Burst CRC and FEC block CRC for 16m uplink and downlink data channel

IEEE C802.16m-08/1386r2

Re : TGM SDD: Other (Reply to Call for comments (IEEE 80216m-08/040) on SDD (IEEE 80216m-08/003r5)

To discuss and adopt the proposed text in the revision of the 802.16m SDD

Figure 43 Channel coding block diagram

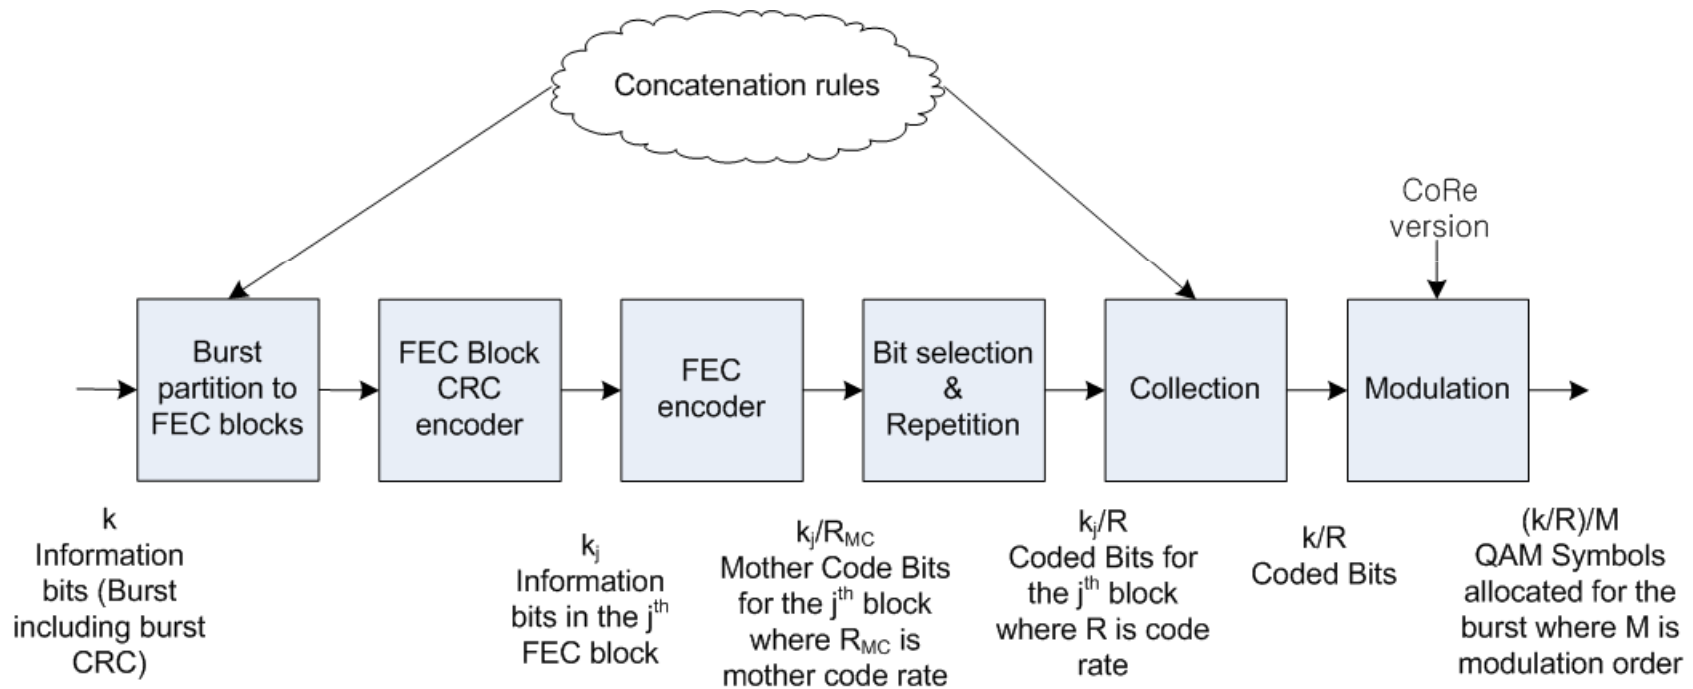
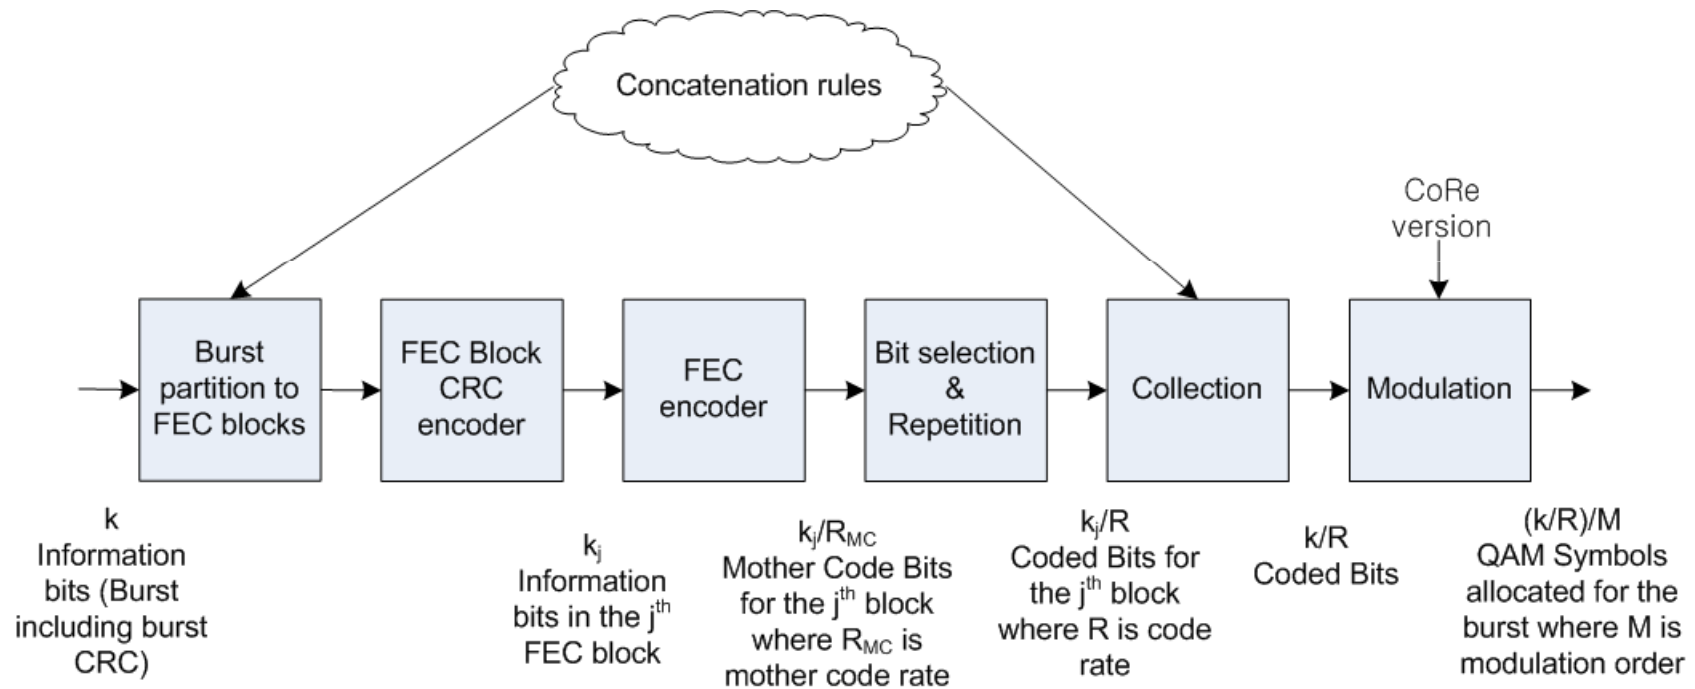
- Add FEC block CRC per FEC block in addition to Burst CRC
 - 16-bit FEC block CRC
 - 16-bit or 24-bit burst CRC
 - Exact length of the burst CRC is FFS

- Page 102, line 15,
 - Replace Figure 43 by the following figure:

- 11.13.1.1 Block diagram
